**Subject: MHI's Responses to US-APWR DCD RAI No. 422-2823 Revision 0**

Responses to Request for Additional Information  
No. 422-2823 Revision 0

**MHI's response to the RAIs relative to head loss tests originally raised for Comanche  
Peak 1&2 GL2004-02 responses**

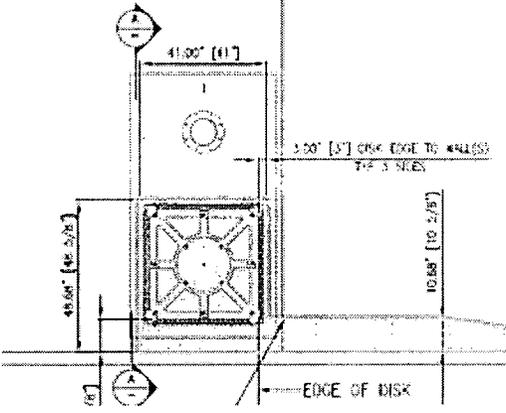
10	<p>Sufficient information was not provided in the supplemental responses dated February 29, 2008, and November 26, 2008, to provide assurance that the flow conditions simulated in the strainer head loss test flume are prototypical or conservative with respect to</p>	<p>To resolve this RAI, prior to testing the plant and test flume configuration CFDs will be compared to confirm the flow stream velocities and TKE of the test flume is equivalent to and / or bounding compared to the plant configuration. Comparisons shall be similar</p>

RAI No.	NRC question	US-APWR approach for resolution
	<p>the plant conditions. Therefore, please provide plots of velocity and turbulence contours in the containment pool for the bounding computational fluid dynamics cases with respect to these two parameters that include the entire pool and which are based on the computational fluid dynamics model used in the debris transport analysis. Please also provide close-up plots of the velocity and turbulence contours (which include a numerical scale with units) in the region of the strainer and its immediate surroundings from the computational fluid dynamics model that was used to determine the flume velocities and turbulence levels for head loss testing. Please identify the bounding break scenario that was used to derive the flow parameters (e.g., velocity and turbulence) that were simulated in the head loss test and identify which of the strainers is modeled in the test.</p>	<p>to the approach implemented for Comanche Peak.</p>

RAI No.	NRC question	US-APWR approach for resolution
		<ol style="list-style-type: none"> <li>1. Latent dirt, dust, etc. all along the flow stream</li> <li>2. ~25% of latent fiber "fines"; distributed all along the flow stream</li> <li>3. coating particulates that are not "chips" (if tested)</li> <li>4. the balance of latent fibers</li> <li>5. fiber "fines"</li> <li>6. coating "chips" (if tested)</li> <li>7. fiber "smalls"</li> <li>8. RMI foils (if tested)</li> <li>9. ALOOH chemical precipitates.</li> </ol> <p>Note: Introduction of each debris type above shall be allocated on the basis of 40% near the screen; and 60% at the upstream end of the bounding flow stream.</p>
16	<p>Please justify including a sharp turn directly before the strainer in the head loss flume. This sharp turn may have assisted in the removal of debris and in the creation of a non-uniform bed on the test strainer. Please explain how this sharp change in flow direction is prototypical of the plant. Please explain how the debris diverter was modeled in the computational fluid dynamics simulations. The computational fluid dynamics simulations for the plant condition appear to show velocities significantly higher than 0.1 ft/s near a good part of the strainer surface. Furthermore, the computational fluid dynamics simulations also show that flow does approach the strainers directly over a significant part of their surface area, and that such a sharp change in flow direction directly in front of the strainer is not representative of the velocity vectors approaching the plant strainers.</p>	<p>MHI will test in accordance with the test configuration shown in Figure 1; which shall be confirmed by CFDs to match or exceed the turbulence at the screens in the US-APWR strainer array to the upstream corner of the test strainer. Refer Figure 2 for additional information of recirculation pool configuration of the US-APWR.</p>  <p style="text-align: center;"><b>Figure-1 90° arrangement.</b></p>

**Figure-2 Flow Direction to the Strainer in the RWSP**

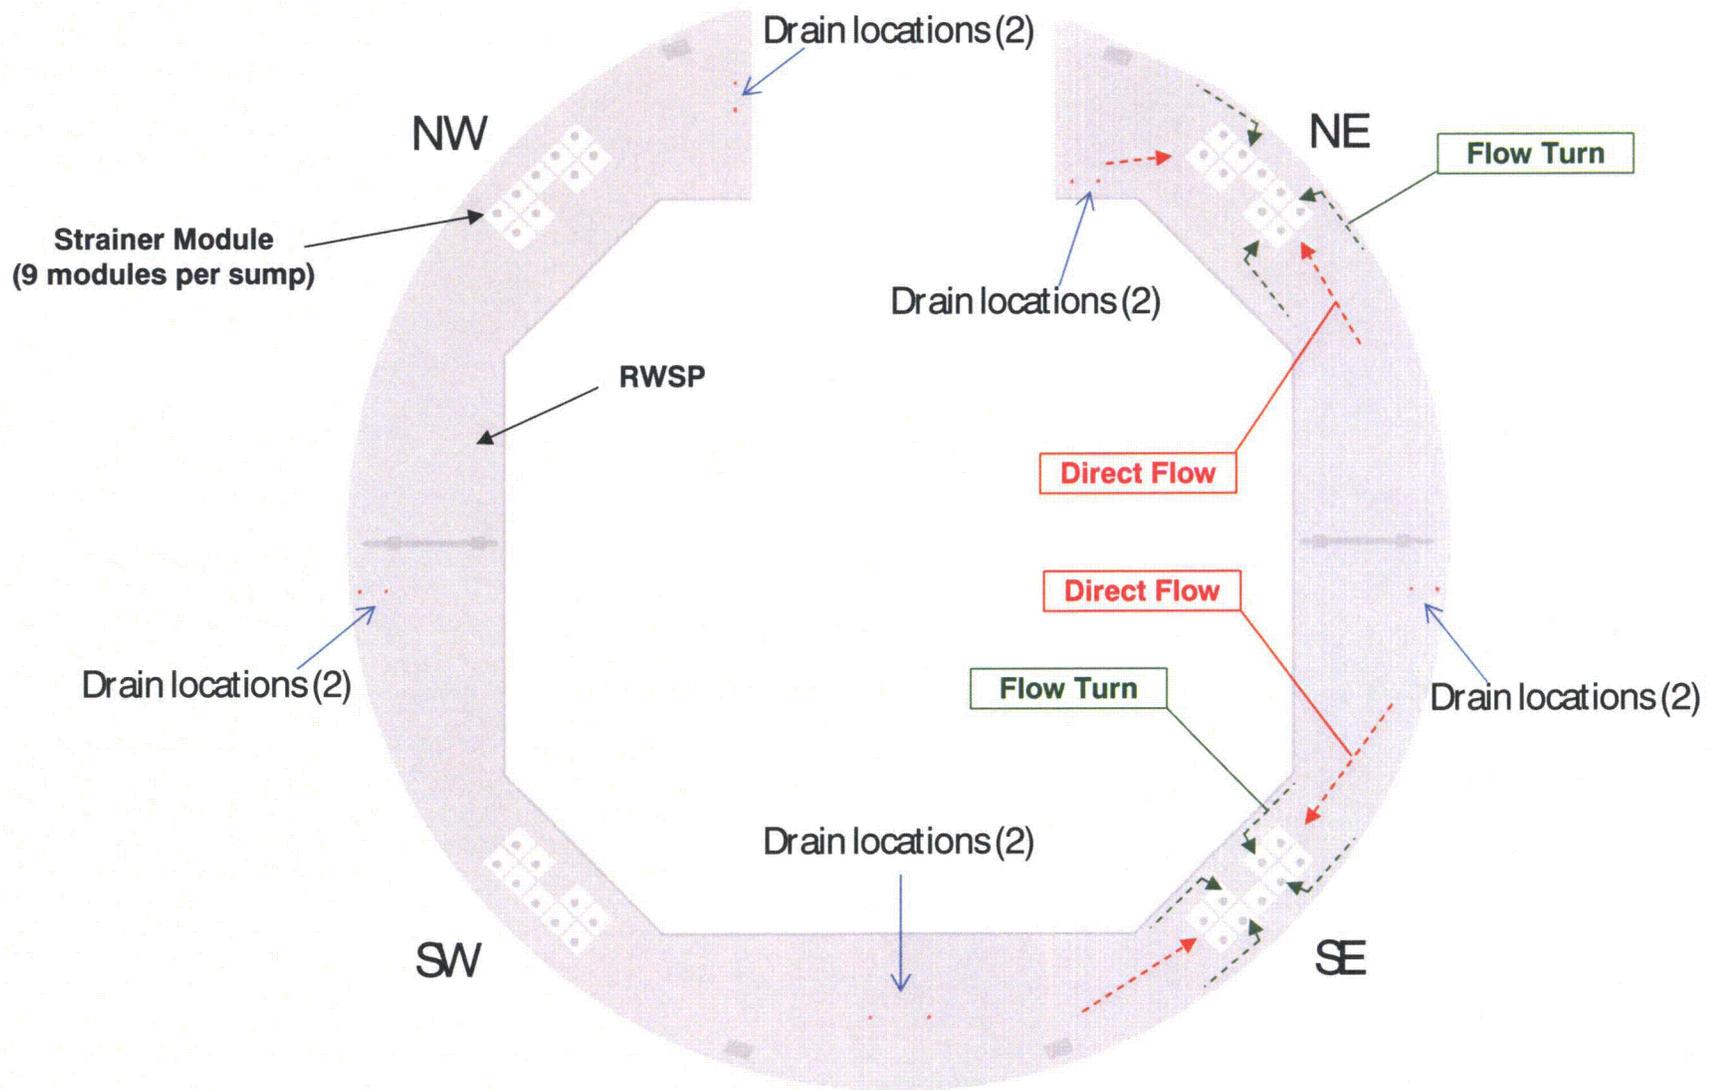
23	<p>Please provide the margin to flashing considering that a more limiting condition may occur at the minimum water level, with the core tube covered only by a small amount of water. The flashing evaluation may have to be performed for several conditions in order to provide assurance that the limiting condition has been identified. With only a small amount of water covering the core tube, it is possible that the clean strainer head loss alone could result in flashing of the fluid within the strainer if some overpressure is not credited in the evaluation.</p>	<p>This RAI does not apply to US APWR testing.</p> <p>Refer MHI response to the above question item 22 for partially submerged strainer as limiting condition.</p>
25	<p>The staff could not determine whether some of the fine fibrous debris was blended into non-prototypical debris. The test photos in attachment D (pages 10 and 29) to the November 26, 2008, supplemental response appear to show clumps of debris that are larger and more agglomerated than would be expected of prototypical fine debris. The debris could have been blended excessively or into a form that is not prototypical of debris created by a steam jet. Please provide information that shows that the fibrous debris had prototypical characteristics when added to the test tank and that the debris was not agglomerated when added. In general the staff considers class 1-3 fibers (reference NUREG/CR-6808, Table 3-2) to be acceptable as fine fibrous debris with the majority being class 2 or 3. In addition, information should be provided that justifies that excessive agglomeration of debris did not occur during the debris addition process.</p>	<p>MHI will apply the protocol to further dilute the fiber "fines" prior to introduction more so than has been implemented for the operating fleet. This is expected to achieve less agglomeration of fines than was witnessed by the NRC for the South Texas Project testing, which was found acceptable.</p> <p>Furthermore, the introduction of fines will be documented with photos and / or a video to confirm the refinement of this effort during the test. This change is not expected to fully eliminate agglomeration; but it will be implemented with the intent to reduce agglomeration more so than has been achieved previously by the protocol implemented with NRC concurrence.</p>
